Access Compliance Report

Public Rights-of-Way

(Curb Ramps)

Intersection ID: 46918	Main Street: BLUE_ASH_LN	Cross Street: PONDEROSA_PINE_LN	Location: SE
ADA ID: 9BD224EA170C	Ramp Type: PerpDiag	Initial Pass/Fail: Fail	Overall Compliance: No
		Severity Score: 25

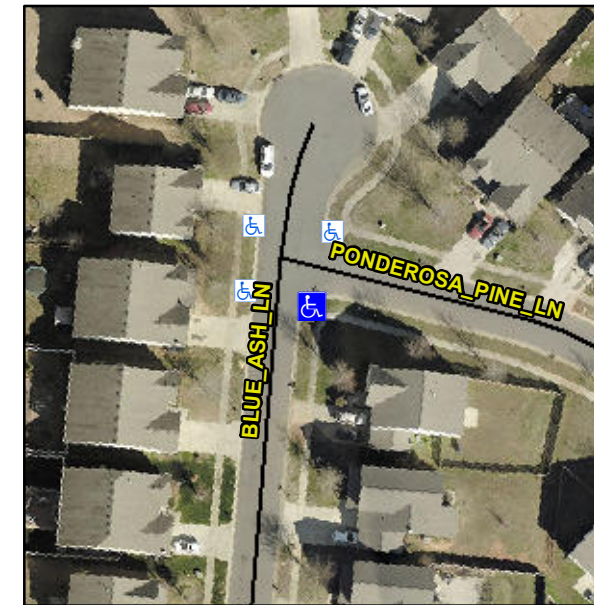
R304.2.2, R304.5.3

Compliance	Description	Data	Compliance	Description	Data
N/A	Ramp Length (in)	83.5	No	Ramp Slope (%)	10.6
Yes	Ramp Width (in)	70.0	No	Ramp XSlope (%)	5.6
N/A	Flare Type LT	N/A	N/A	Flare Type RT	N/A
N/A	Flare Slope LT (%)	N/A	N/A	Flare Slope RT (%)	N/A
N/A	Flare Traversable LT?	N/A	N/A	Flare Traversable RT?	N/A
N/A	Landing Length (in)	N/A	N/A	DWS Provided?	N/A
N/A	Landing Width (in)	N/A	N/A	DWS Contrast?	N/A
N/A	Landing Slope (%)	N/A	N/A	DWS Length (in)	N/A
N/A	Landing X Slope (%)	N/A	N/A	DWS Full Width?	N/A
N/A	Landing Curb? (Y/N)	N/A	N/A	DWS Offset (in)	N/A
N/A	Shared Landing?	N/A			
N/A	Gutter Ponding?	N/A	N/A	Gutter Slope (%)	N/A
N/A	Gutter Lip Ht (in)	N/A	N/A	Gutter X Slope (%)	N/A
N/A	Painted X Walk1?	No	N/A	Painted X Walk2?	No
	X Walk 1 Direction	To N		X Walk 2 Direction	To W
N/A	X Walk 1 Width (in)	N/A	N/A	X Walk 2 Width (in)	N/A
	X Walk 1 Slope (%)	4.2		X Walk 2 Slope (%)	5.9
	X Walk 1 X Slope (%)	2.0		X Walk 2 X Slope (%)	3.5

Remove & Replace Curb Ramp With Two New Directional Ramps or Equivalent.
